## CITY of NOVI CITY COUNCIL

**Agenda Item 3**  
**March 25, 2013**

**SUBJECT:** Approval of the request of Stucky Vitale Architects for Detroit Metropolitan Credit Union JSP12-69, for the Preliminary Site Plan, Woodland Permit and Stormwater Management Plan approval. The subject property is located at the northeast corner of the intersection of Main Street and Novi Road in the TC-1, Town Center District. The development area is 0.83 acres and the applicant is proposing an approximately 3,000 square foot Detroit Metropolitan Credit Union.

**Sheet No. :**  
SP1.1

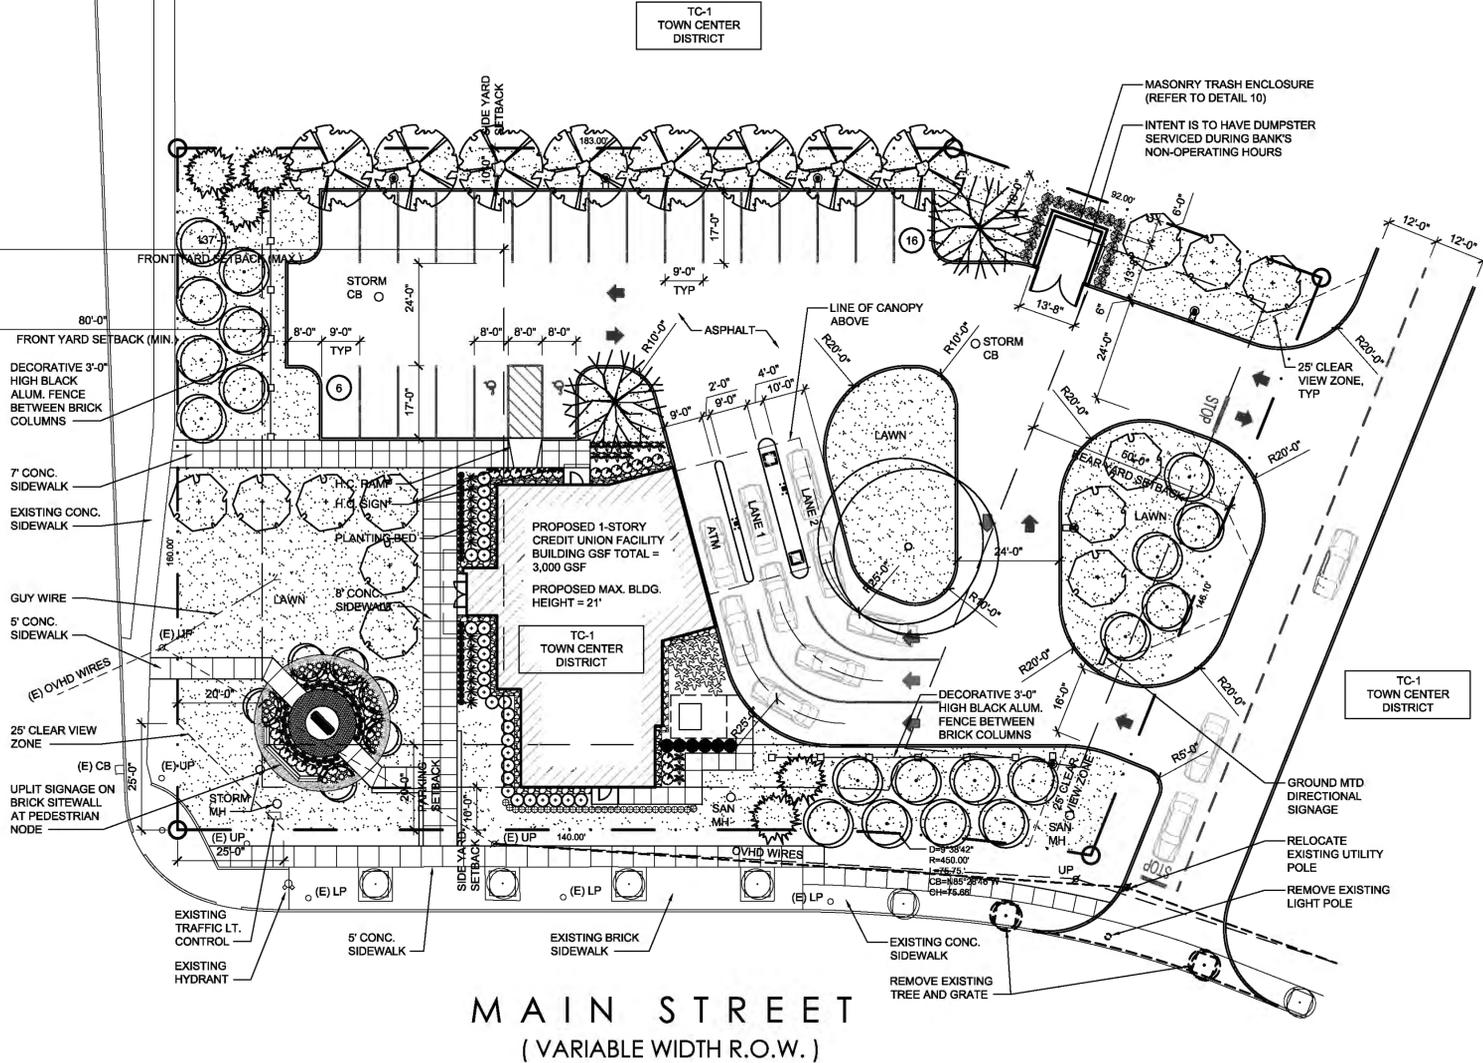
14. **A plan note should be included stating that all parking space dimensions (width as well as length) are referenced to the face of curb.**
15. **To comply with City policy that assumes a 2-ft parking overhang, the curb along the northernmost bank of parking stalls should be reduced in height to 4 inches. This should be indicated by a detail and/or note on sheet SP1.1 as well as revised elevations on sheet C-2. In a related matter, the Curb and Walk detail now appearing on sheet SP1.1 should be corrected to show a 4-inch (not 6-inch) walk height.**

**Sheet Title:**  
STORM WATER MANAGEMENT PLAN

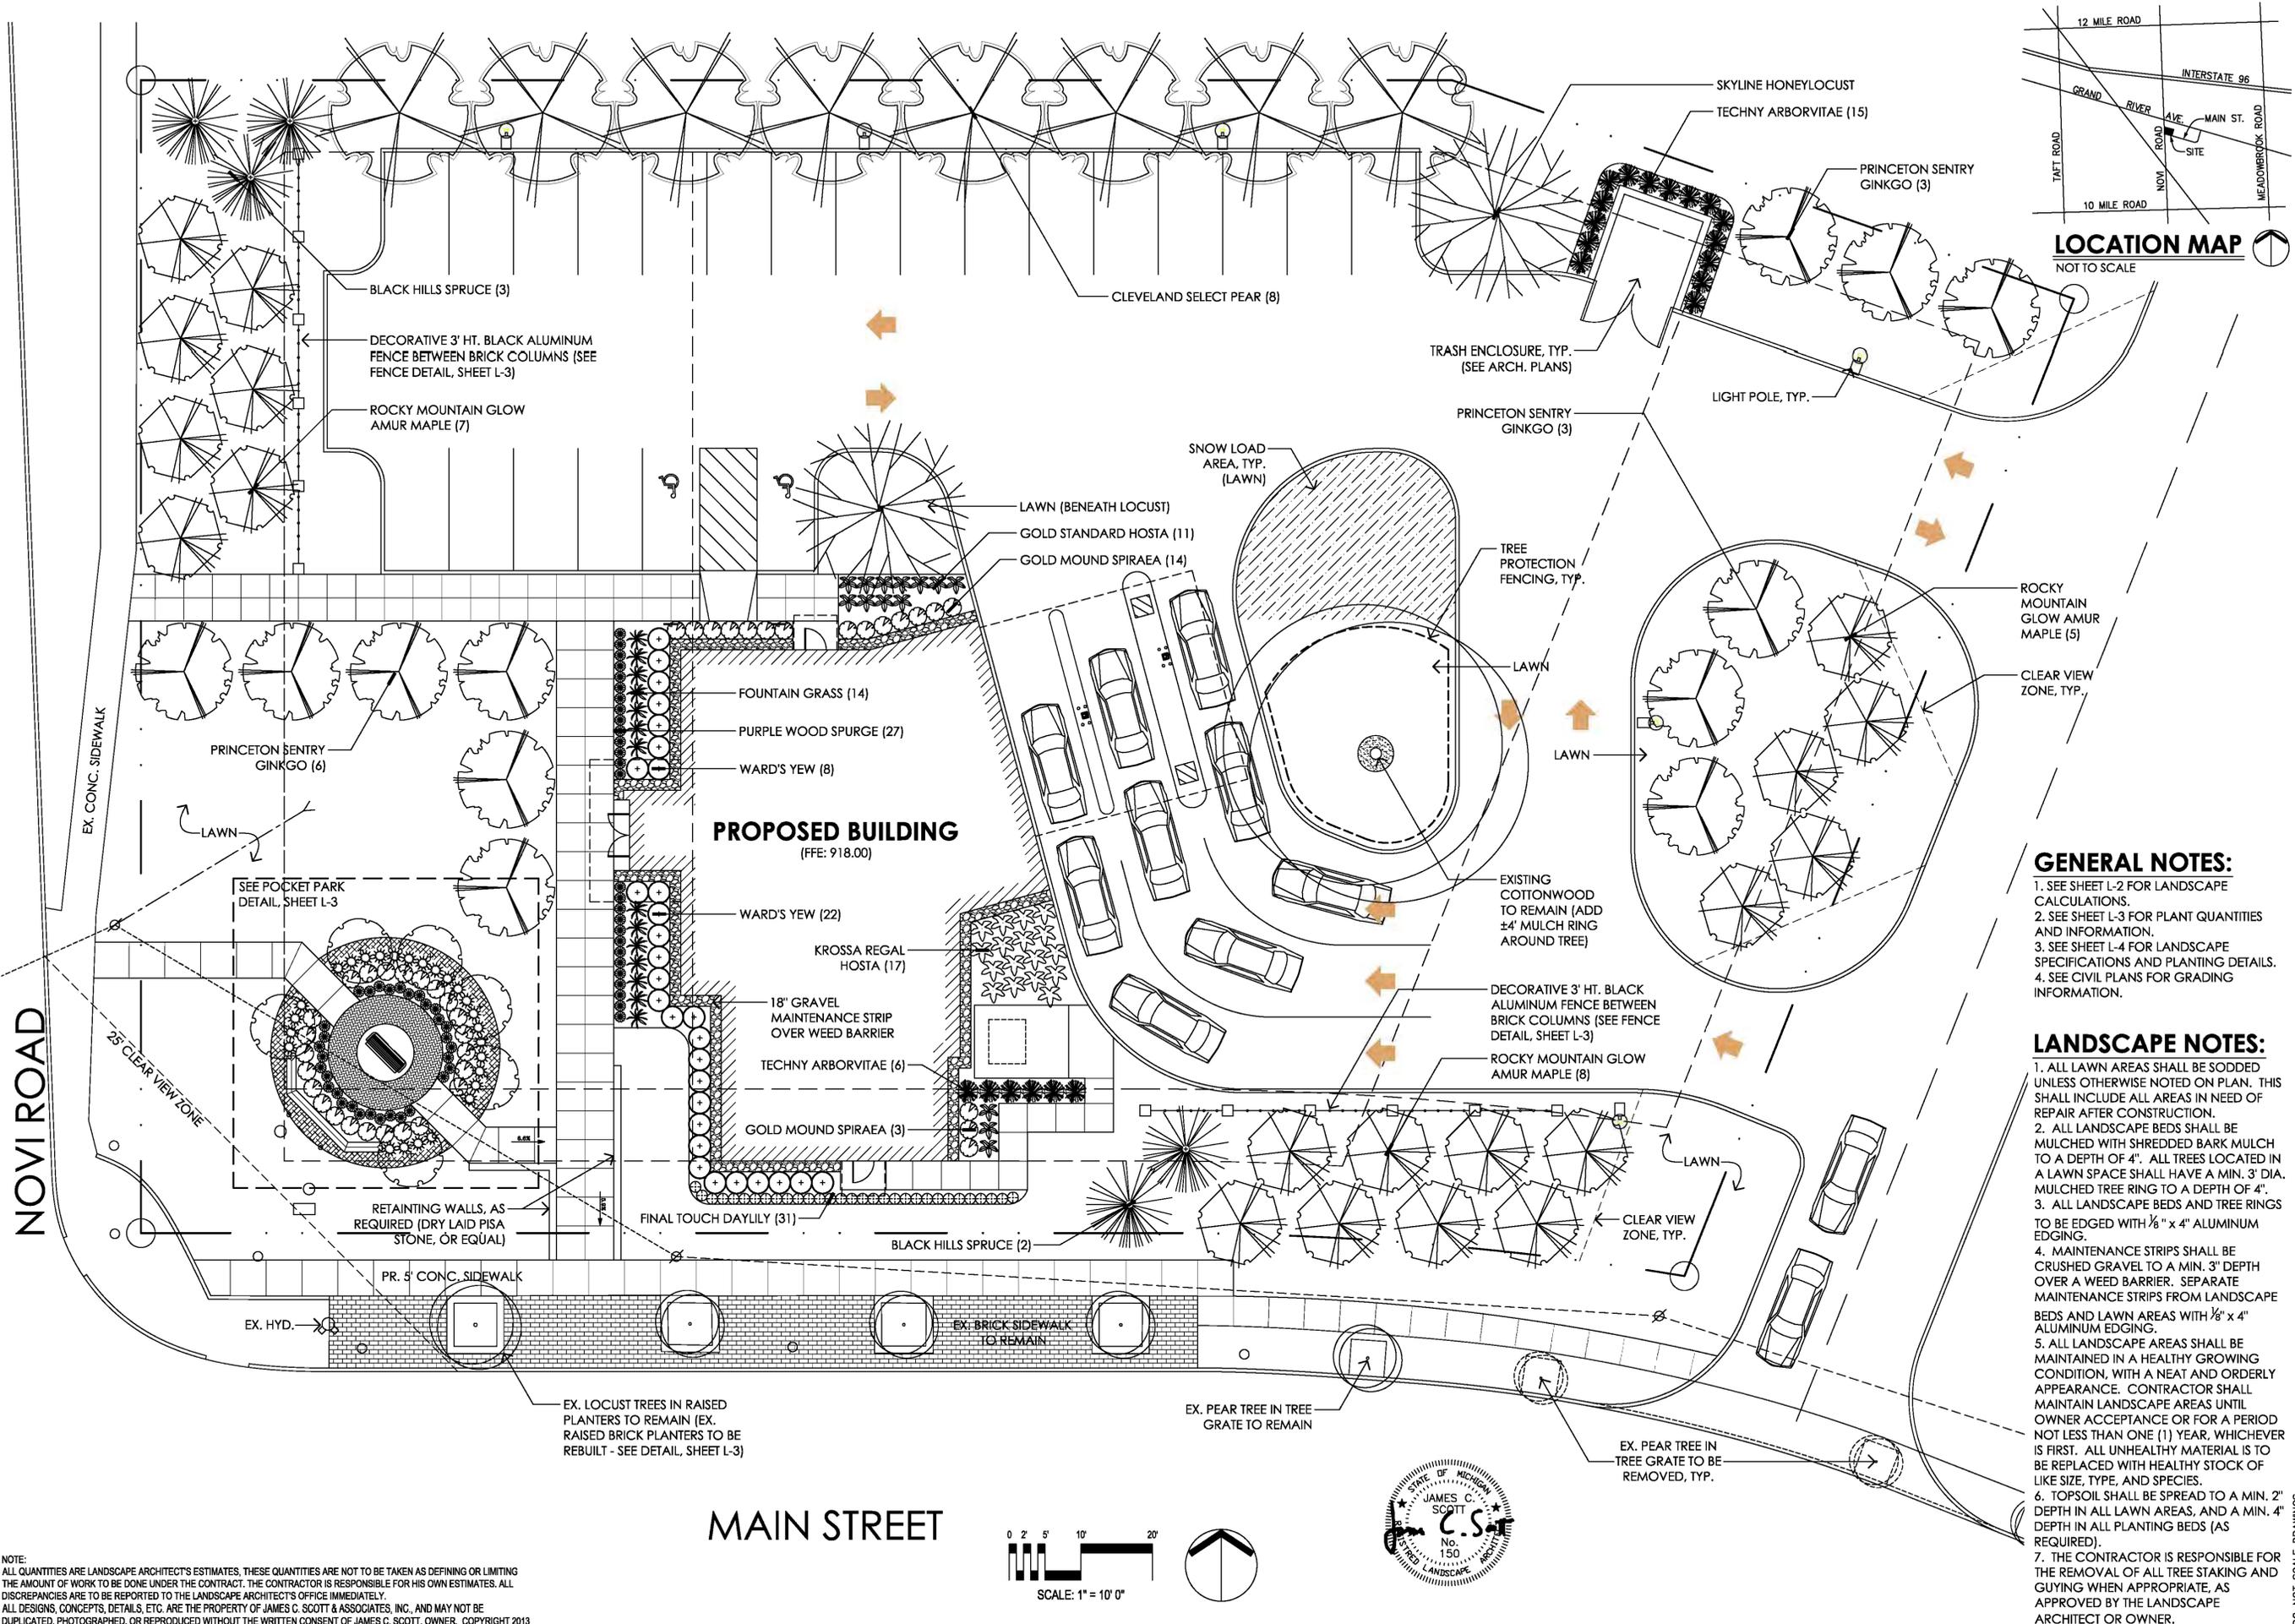
13. Denote an overland route for storm water that would occur in the event that the underground system cannot accept flow. This route shall be directed to a recognized drainage course or drainage system. Verify that any structures accepting overland flow are capable of handling the 100-year flood capacity.

14. Provide an underground detention system cross-section with critical elevations (bankfull and 100-year storm hydraulic grade lines) demonstrating that the detention system is 3 feet above ground water and has the required 1 foot of freeboard between the high water elevation and the subgrade below the pavement.

15. Revise the composite 'c' factor calculation to ' $26,227/38,637=0.68$ ' from ' $38,637/26,227=0.68$ ' as shown.

Drawn by :  
 BMW  
 Checked by :  
 JCS  
 Sheet Title :  
 LANDSCAPE PLAN  
 Project No. :  
 2012.023  
 Sheet No. :  
 L-1

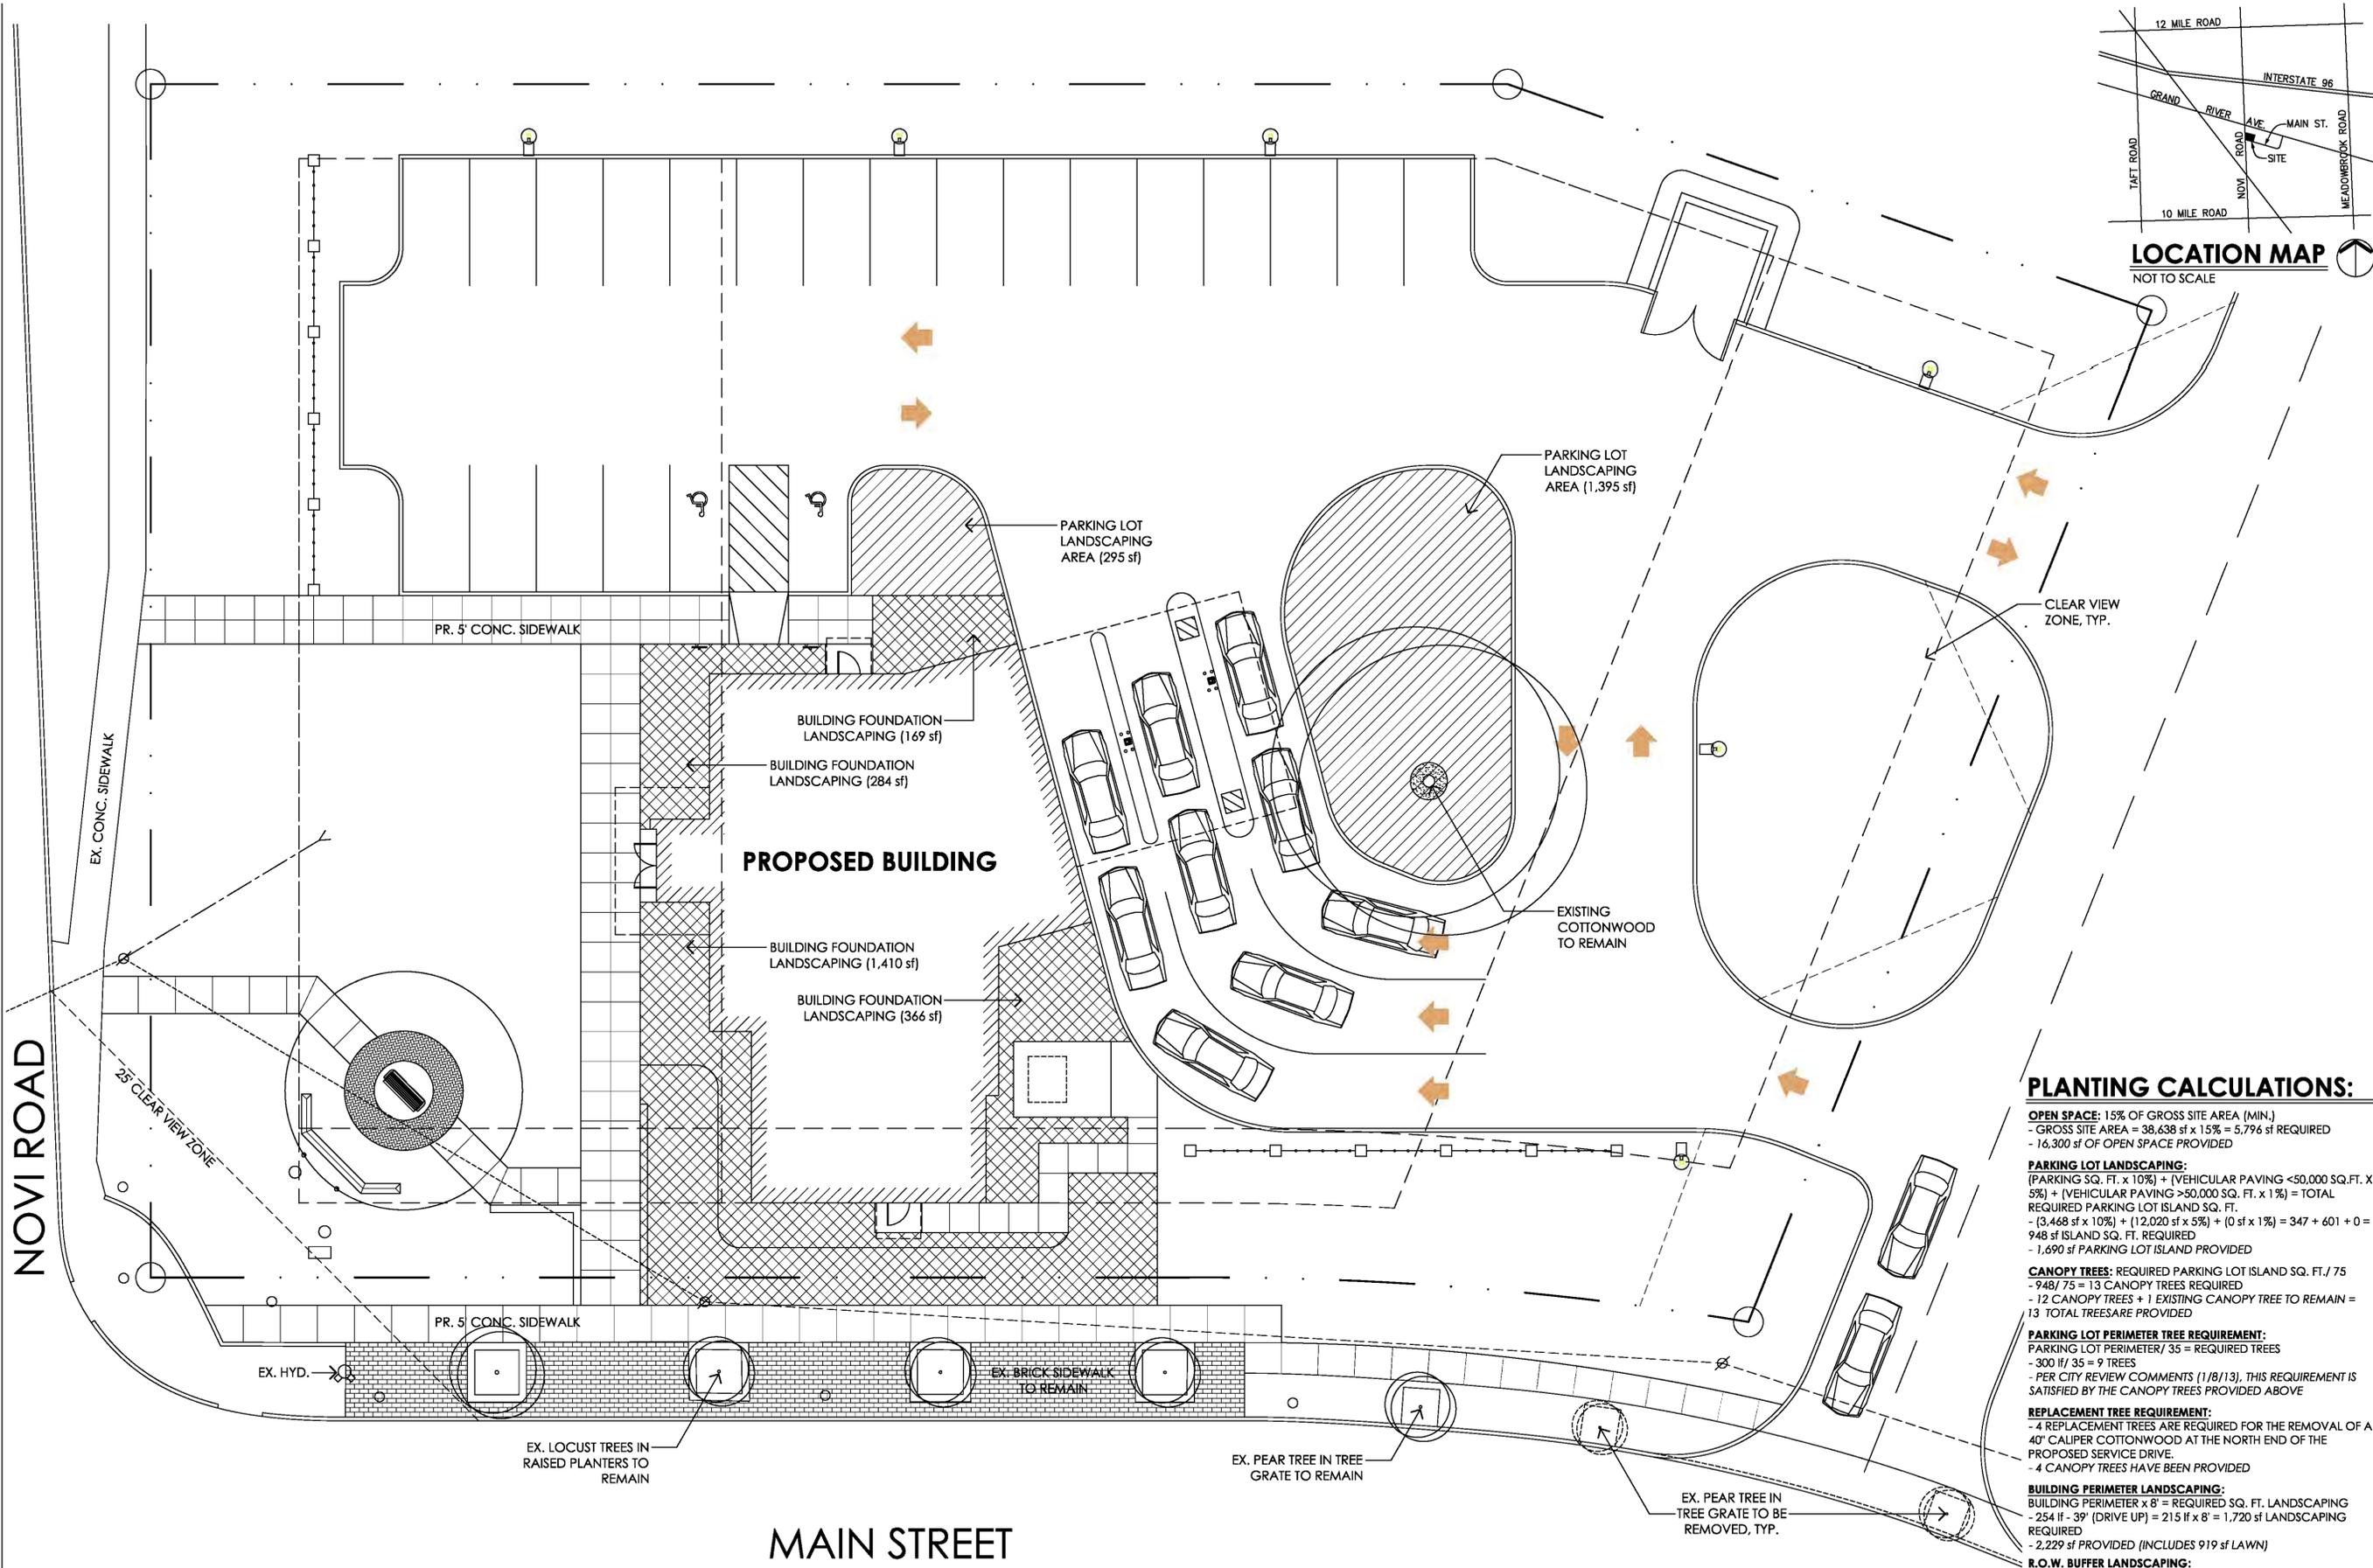
1. Interior Parking Landscape Area is required. Adequate landscape area has been provided.
2. Parking Lot Canopy Trees are required. Calculations show that 18 trees are required. This requirement has been met.
3. Please show snow storage areas on the plan as required.

1. Planting Notations and Details per the requirements of the Ordinance and the Landscape Design Manual have been provided.
2. A note on Sheet L-1 states that the landscape contractor shall maintain the landscape for a period of 1 year. The ordinance requires a guaranteed maintenance period of two years. Please adjust the note accordingly.

1. Please verify that all underground and overhead utilities, both existing and proposed, on the landscape plan.
2. Please provide details on the proposed signage.

Item #3: Please show snow storage areas on the plan as required.  
*Snow Load areas are indicated on Sheet L-1.*

Item #2: A note on Sheet L-1 states that the landscape contractor shall maintain the landscape for a period of 1 year. The ordinance requires a guaranteed maintenance period of two years. Please adjust the note accordingly.  
*This note has been adjusted as requested. The same note on Sheet L-3 has also been adjusted.*

Item #1: Please verify that all underground and overhead utilities, both existing and proposed, are shown on the landscape plan.  
*All utilities have been verified and included on the Landscape Plan, Sheet L-1.*

**Comment #1:** The applicant will be required to provided 4 woodland replacement credits for the removal of this (40" landmark) tree.  
*Four replacement trees are shown on the landscape plan (Sheet L-1) and the corresponding credits are included in the Planting Calculations presented on Sheet L-2.*

**FENCE DETAILS**

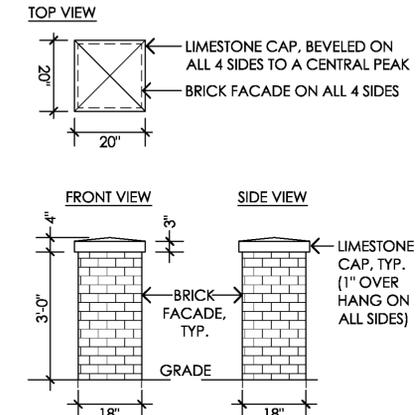
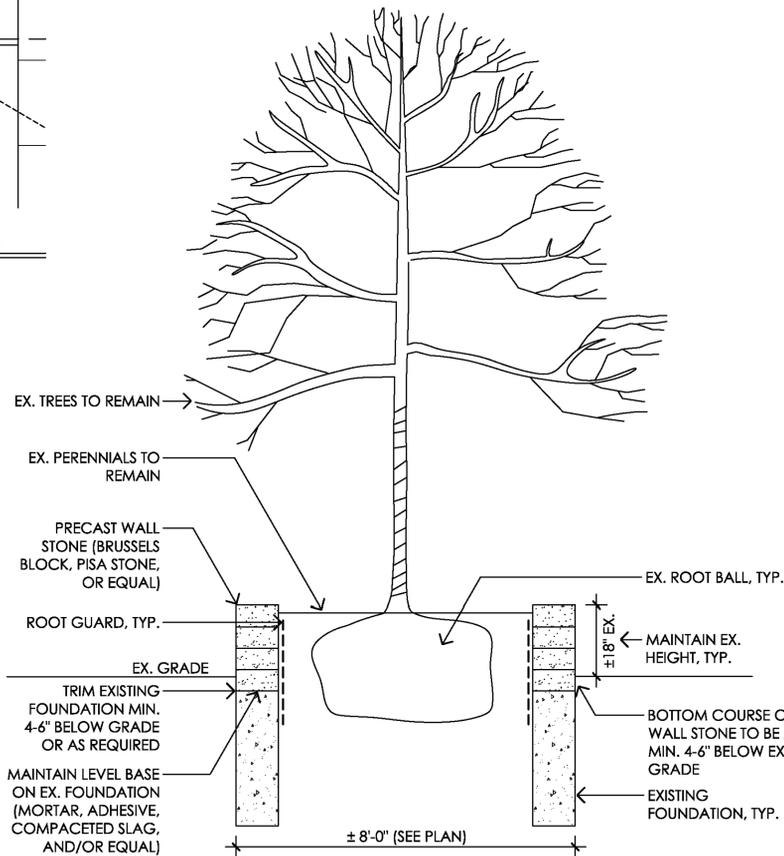
1. A 3' tall decorative brick wall is required along the Novi Road and Main Street right-of-ways adjacent to parking and vehicular access areas. A decorative fence with brick piers may be used with the consent of the Planning Commission. It should be shown that the goal is to match the overall landscape scheme for development of the area. The Applicant has appropriately proposed decorative fencing with brick piers in areas adjacent to parking. Staff would support the use of the fencing as it is in keeping with the character of the district.
